PLANNING BOARD PACKET

**LEGAL ADVERTISEMENT
PORTLAND PLANNING BOARD MEETING**

- ii. Level III Preliminary Site Plan : 421 Warren Ave.; 7 unit Commercial Complex – PH Warren Avenue, LLC, Applicant. The Board will consider a proposal to construct a 28,000 sq. ft. single level building to create 7 commercial units. Vehicle access would share the existing access for 429 Warren Ave. The project is located on a 9.6 acre lot that was formerly part of the site known as "Warren Green".

To: Chair O'Brien and Members of the Portland Planning Board
From: Nell Donaldson, Planner
Date: March 15, 2014
Re: Amendments to Conditional Rezoning Agreement, St. Lawrence Arts Center
CBL: 003-L-001
Meeting Date: March 18, 2014

DRAWN: CMW	DATE: NOVEMBER 2013
DESIGNED: SRB	SCALE: AS NOTED
CHECKED: SRB	JOB NO. SP-M104
FILE NAME: SP-M104-GRAVEL WETLAND SECTIONS	
SHEET	C-4.2

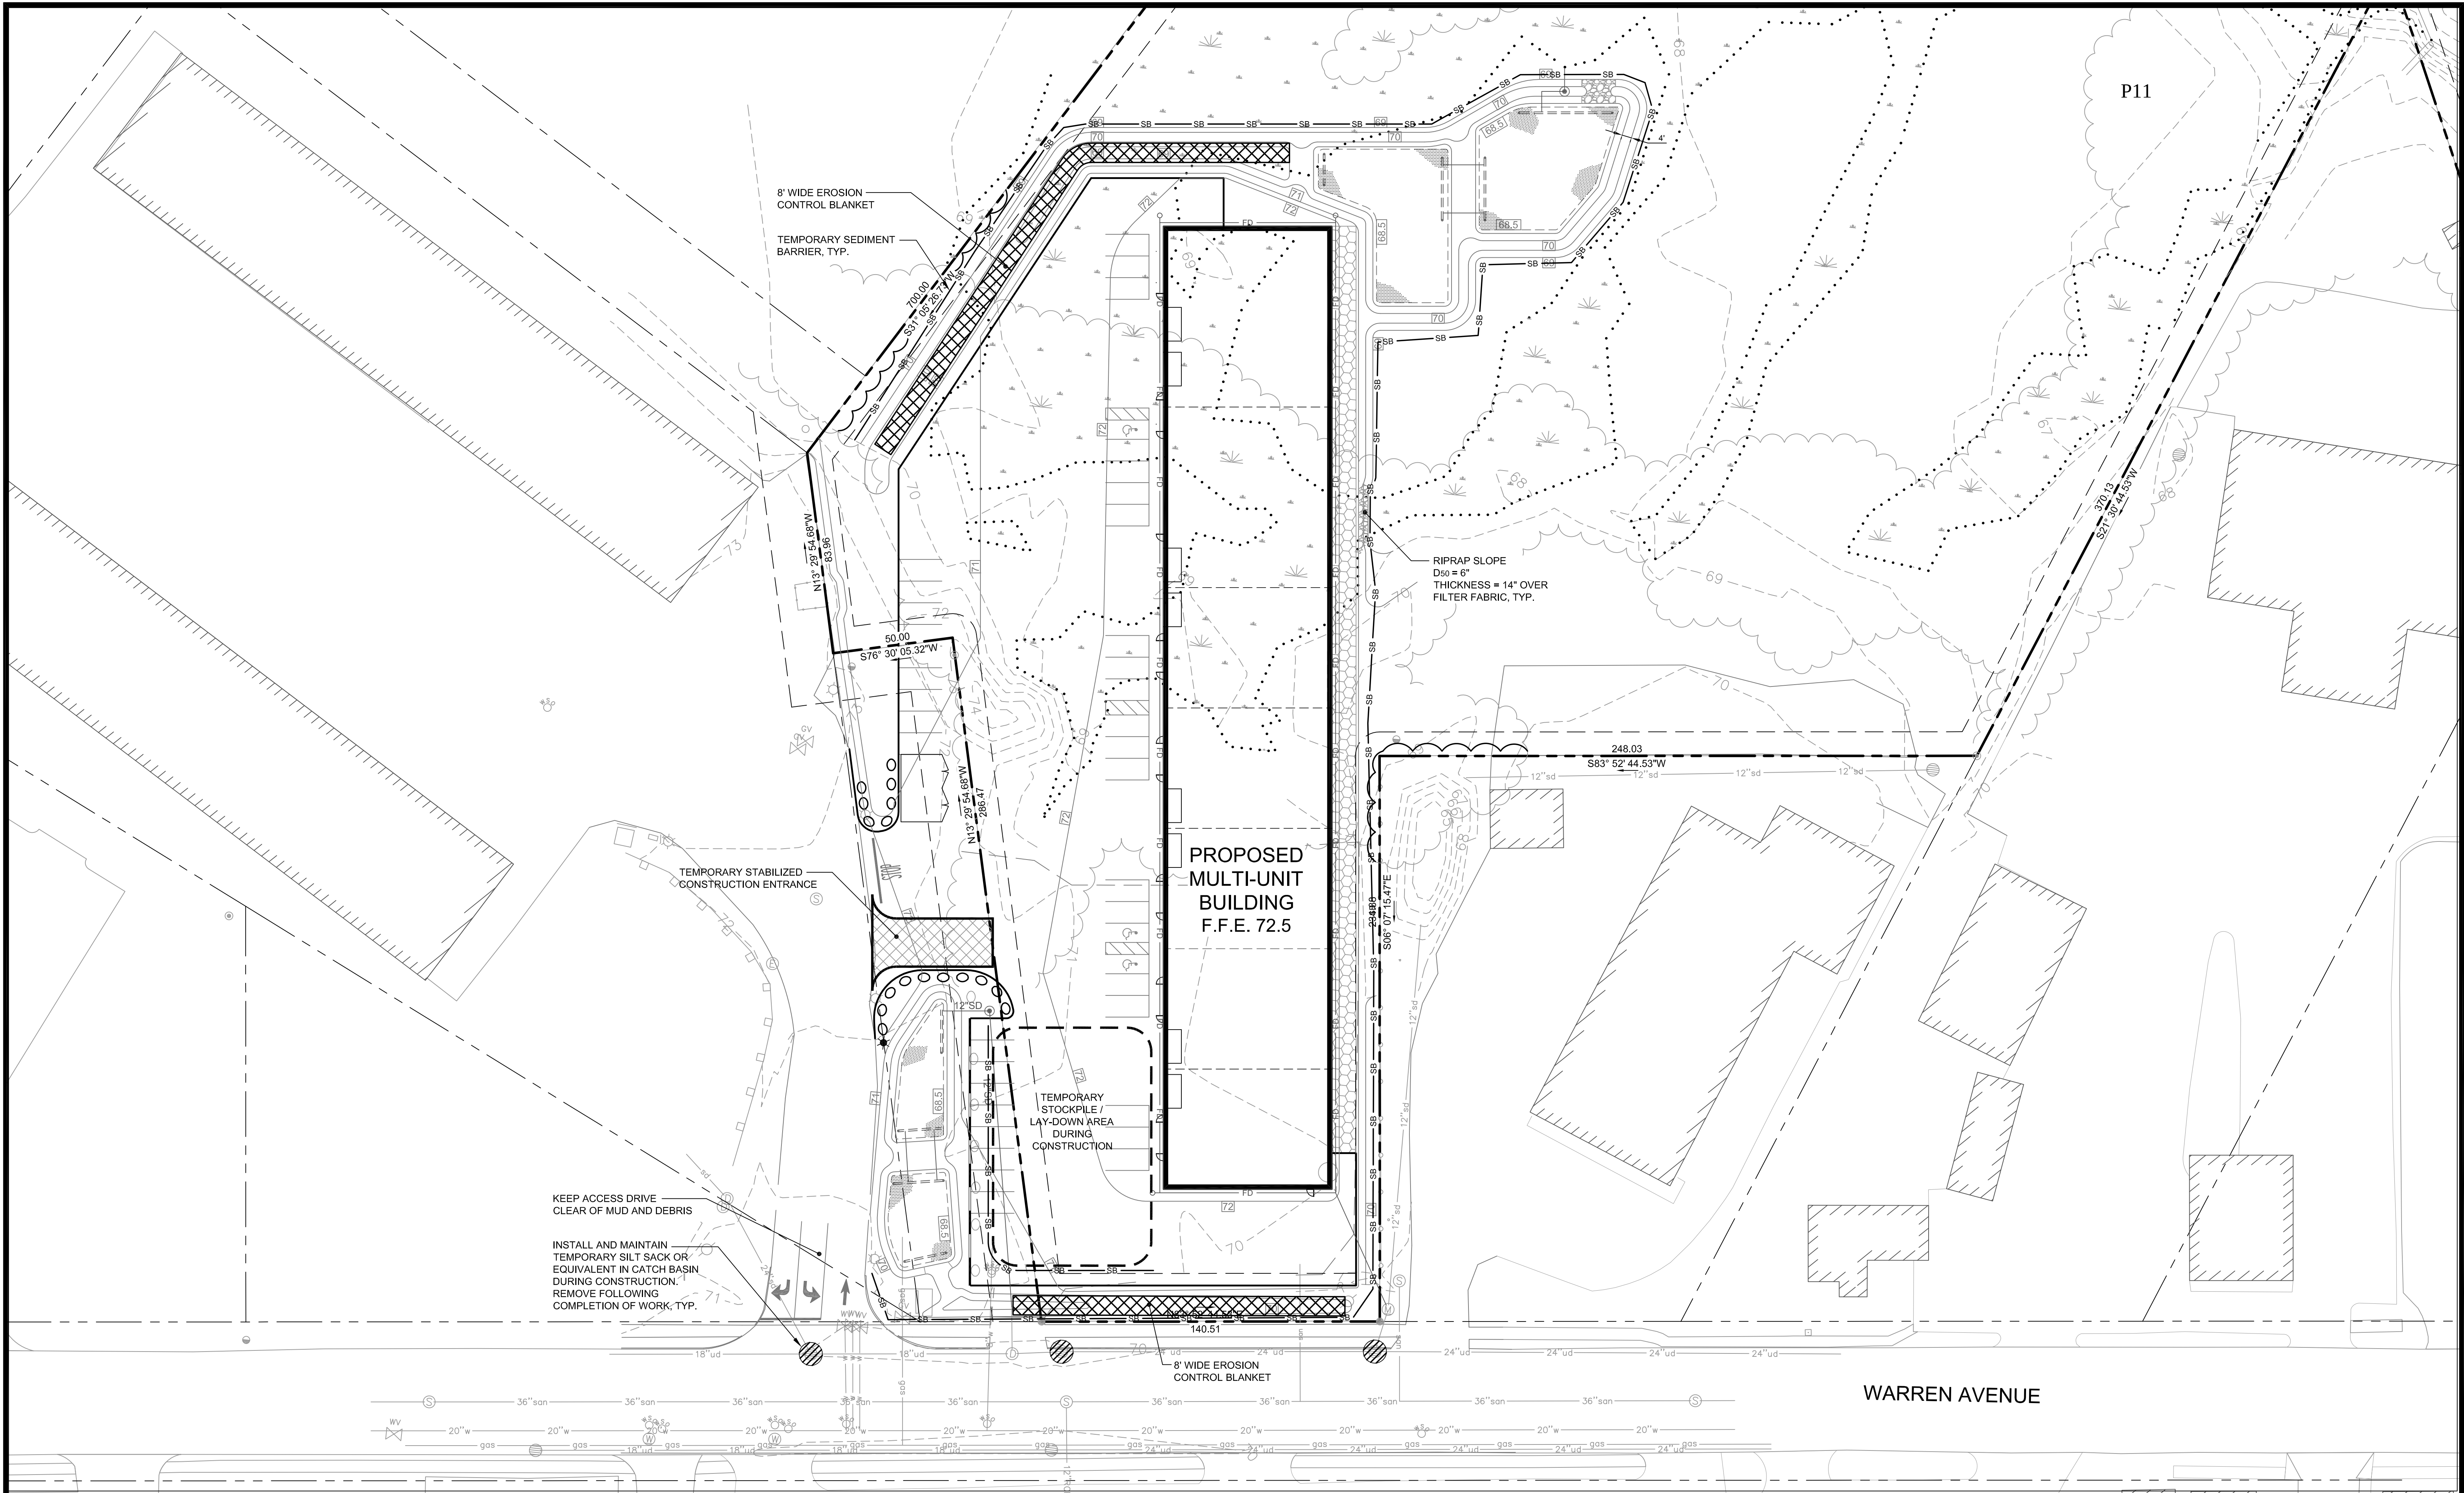
- 6) **Gravel Wetland Design Comments:**
 - a) On Sheet C-4.2, the titles for the plan view and section view incorrectly note Gravel Wetland #1; these should state Gravel Wetland #2.

WATERSHED LEGEND p17

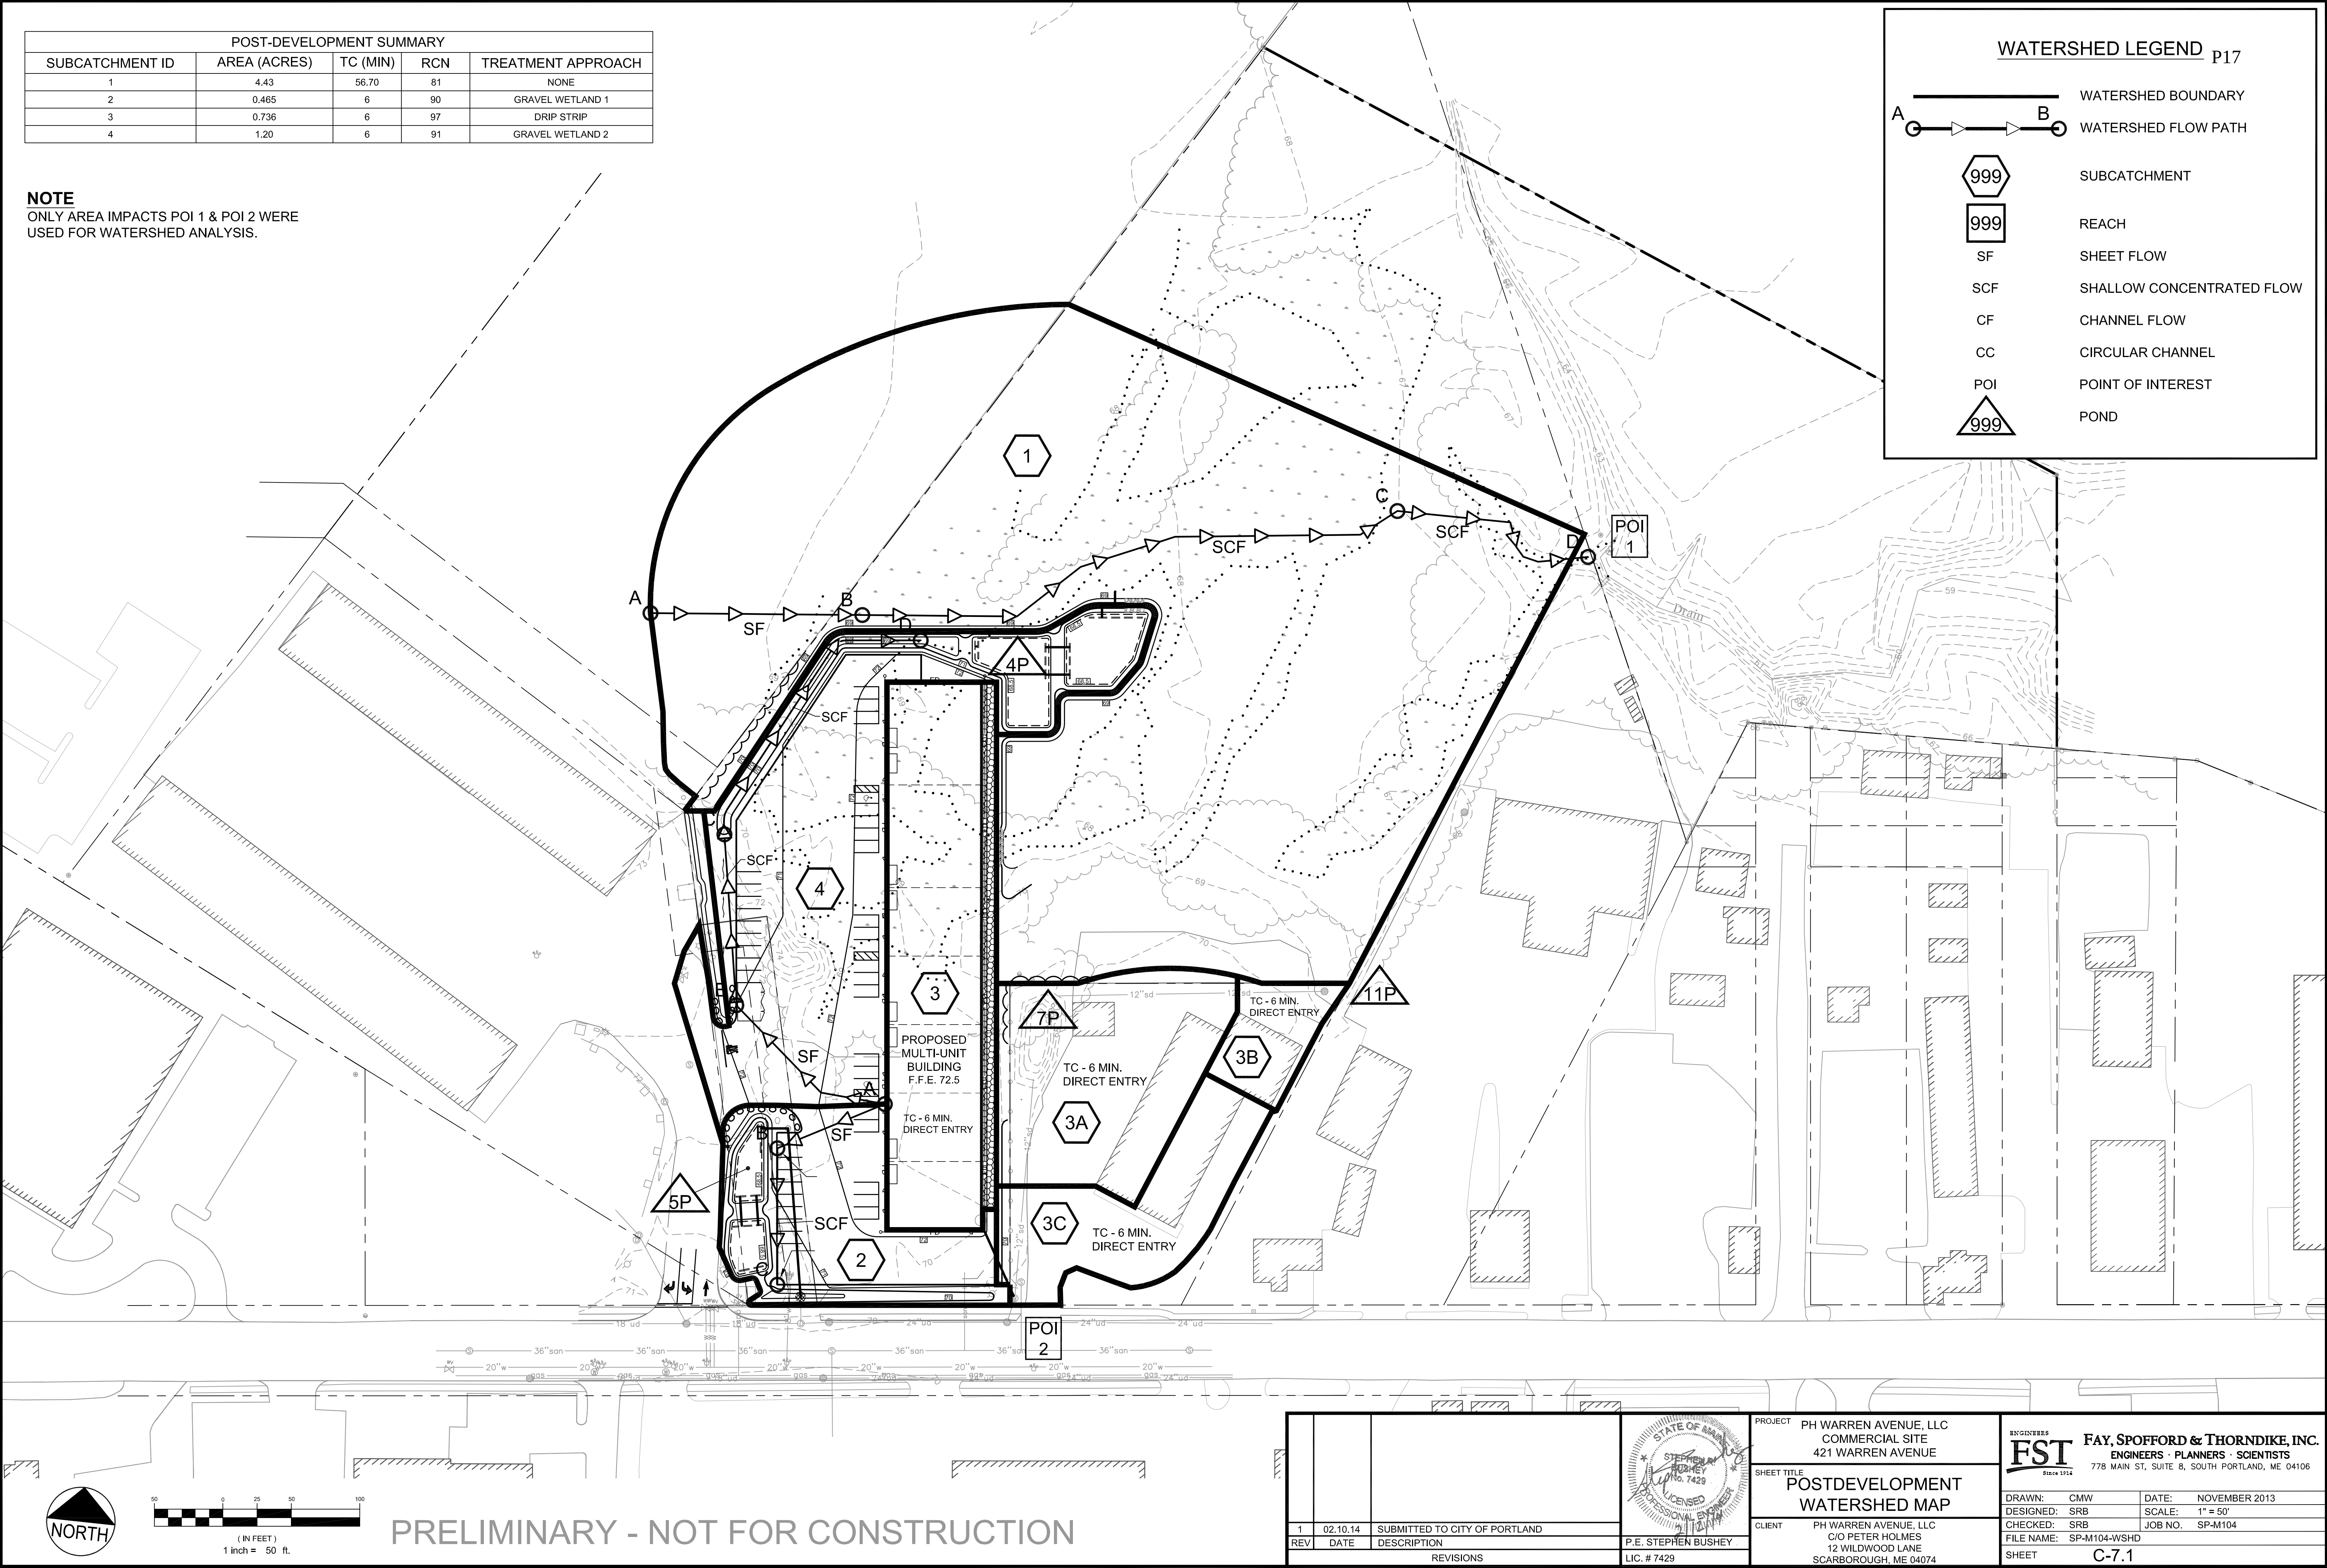
- e) The pervious and impervious area treated numbers contained in Table 11 of the Stormwater Management Report do not appear to agree with those utilized in the HydroCAD model or noted on the Post Development Watershed Map (C-7.1); the Applicant should clarify.
